**RE: APS Family School East Side
3303 Monroe St NE
Drainage Plan and Report
Engineer's Stamp Date: 1/30/2017 & 12/12/2016
Hydrology File: G17D019A**

Based upon the information provided in your submittal received 1/31/17, the Drainage Plan and report is not approved for Building Permit. The following comments need to be addressed for approval of the above referenced project:

A1 **SITE DRAINAGE PLAN**
SCALE: 1" = 20'-0"

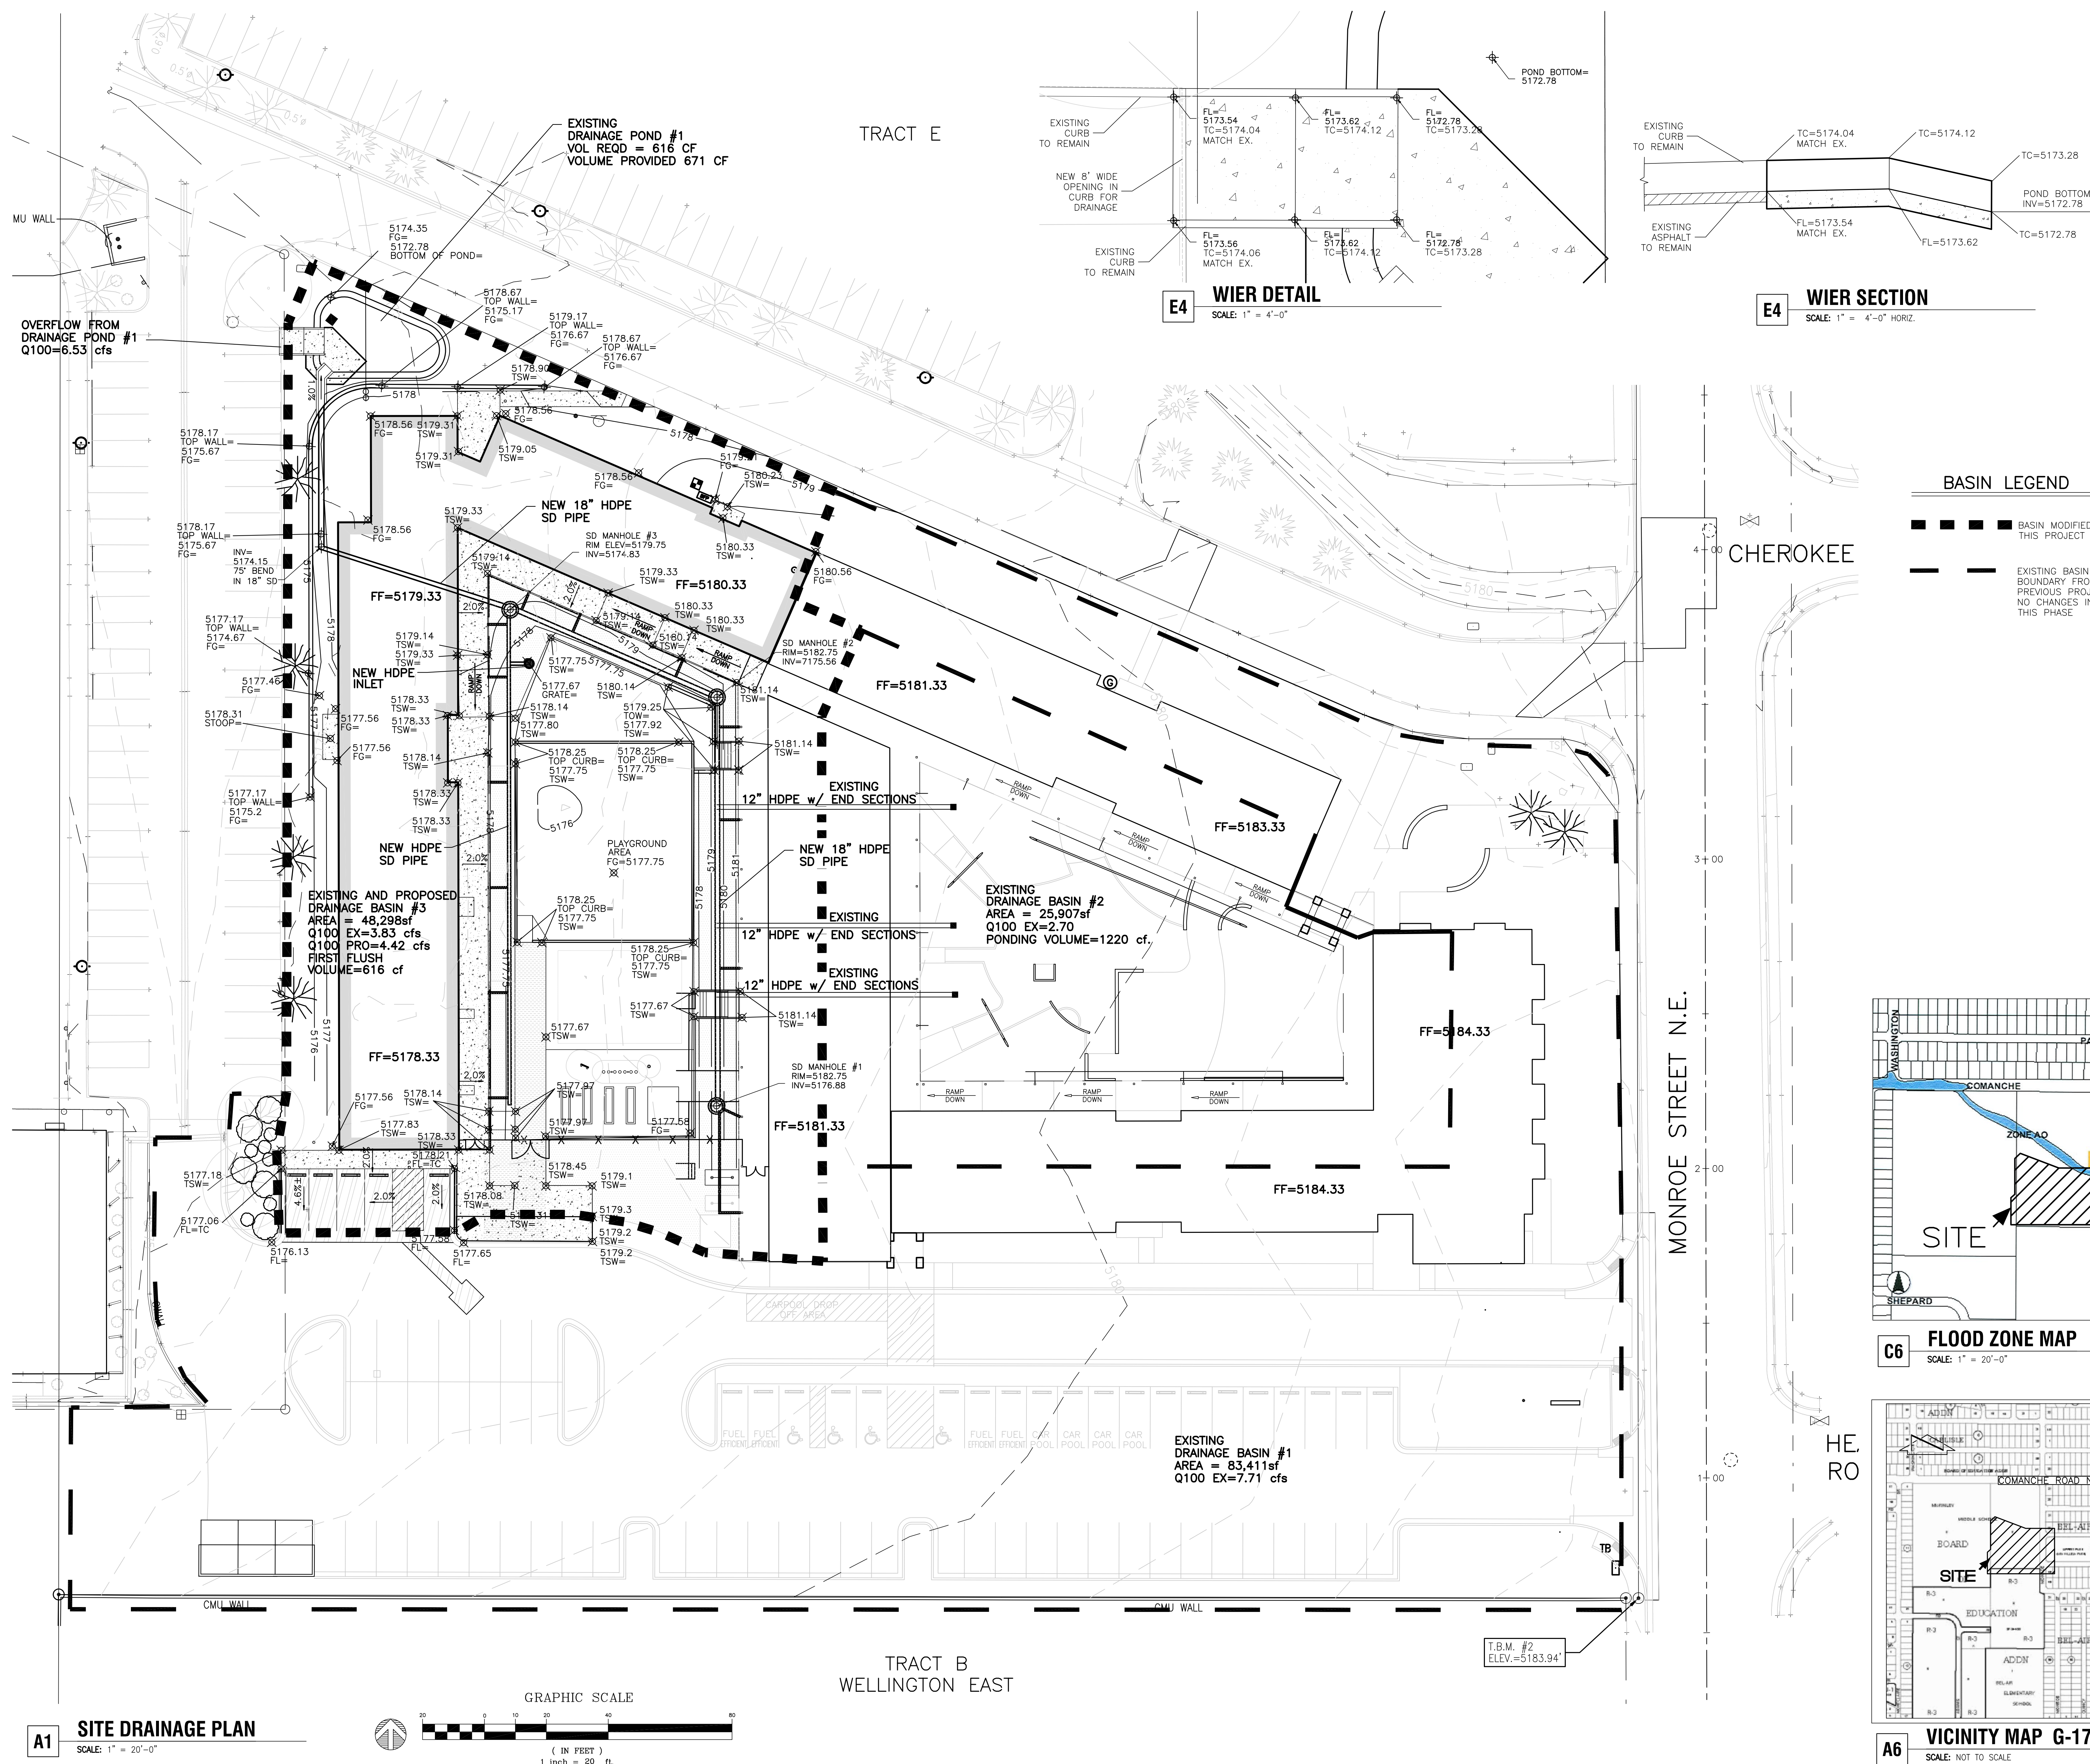
1. Define the limits of construction and provide area. Submittal of an erosion and sediment control plan is required prior to building permit approval if the disturbed area is over 1 acre. Please contact Curtis Cherne P.E at 924-3420 for question regarding ESC plans.
2. Clarify how the storm drain outfalls through the wall and into the pond with a detail view/notes and include dimensions and inverts. In your previous submittal, this information was added for the overflow weir, but not the storm drain outfall.

1. Use RVP Class IV underneath the building and the wall
2. Call out Section and detail views for the weir
3. Correct invert elevation on SD Manhole #2
